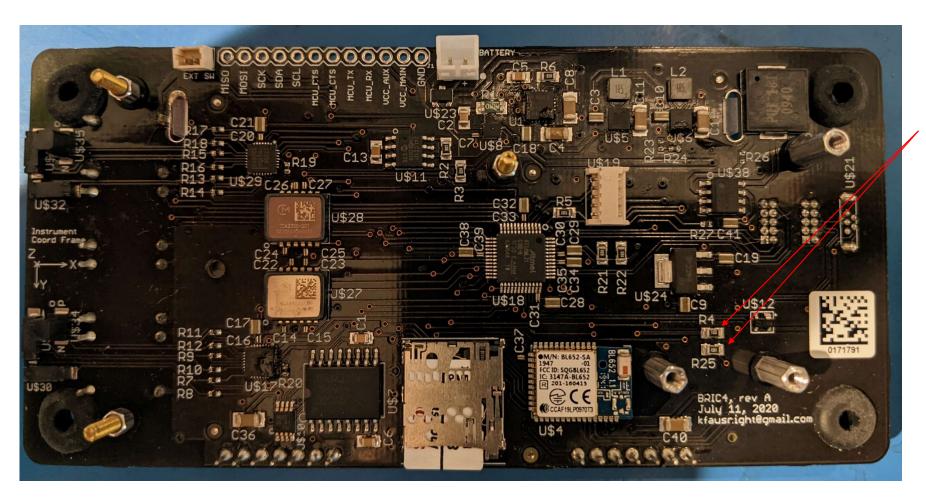
Current draw during "Off" state due to pull-up resistors **R4** and **R25**.

Pull-down resistor on BL652 module cannot be disabled causing unnecessary quiescent current draw.

Remove **R4** and **R25** SMT resistors.
